SAFETY RECALL BULLETIN

NHTSA RECALL 22V079

AUTOCAR, LLC SAFETY RECALL DC-2201

Autocar, LLC has determined that a defect, which relates to motor vehicle safety, exists in 132, 2020-2022 model year Legend (DC) chassis. The grille bezel may be insufficiently attached, allowing it to detach from the vehicle.

Figure 1

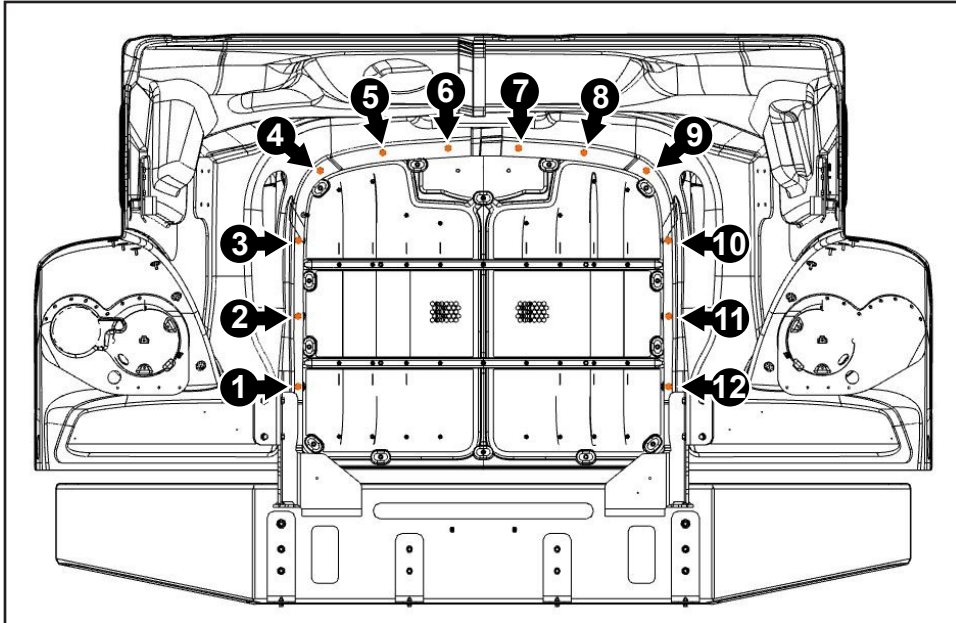
3. Working from inside the raised hood remove (12) fasteners and set aside for reinstallation (see Figure 1).

Figure 2

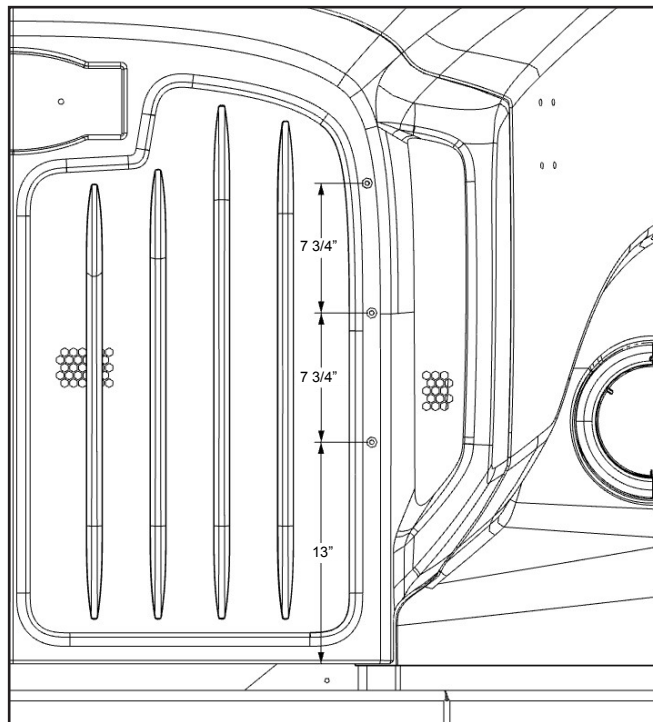
4. Remove the grill from the hood and using a 1/4" drill bit, drill six holes in the grille starting at the bottom of the grille measure up 13" for the first hole. Then measure 7 3/4" up from the first hole to the second hole. From the second hole, measure another 7 3/4" for the third hole. Repeat this process for the opposite side of grille until all six holes have been drilled (see Figure 2).

Figure 3

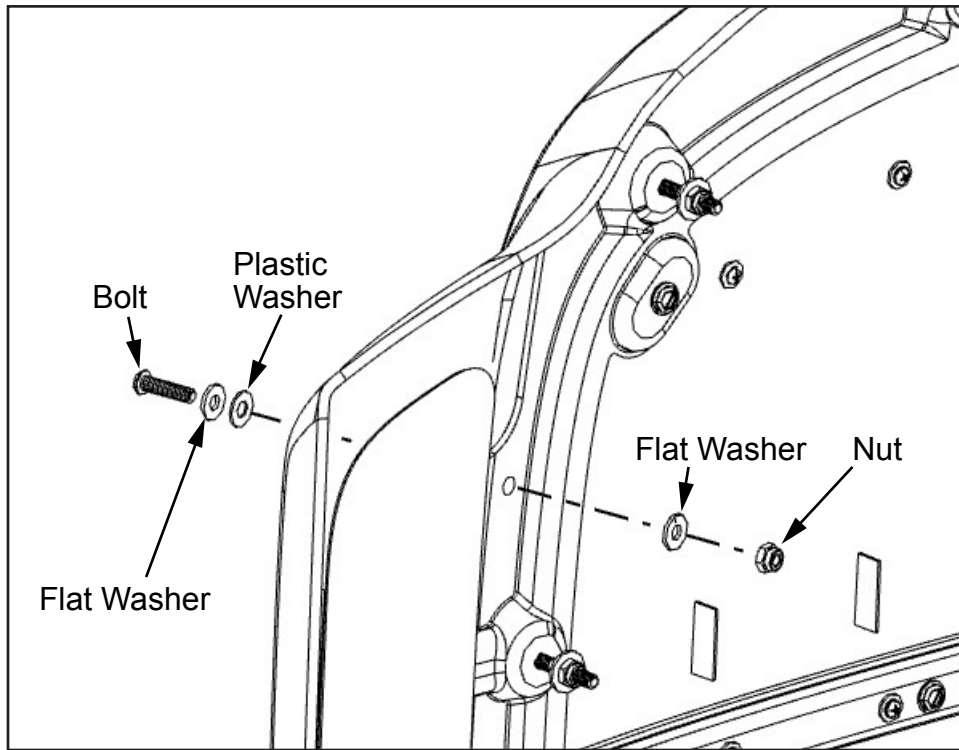
5. In each of the previously drilled 1/4" holes install (1) GE401525ES12 bolt, (2) GE811625NS01 flat washers, (1) A6200017-001 plastic washer, and (1) GE282025BS01 nut. Tighten to 79 lbs.-in of torque (see *Figure 3*).
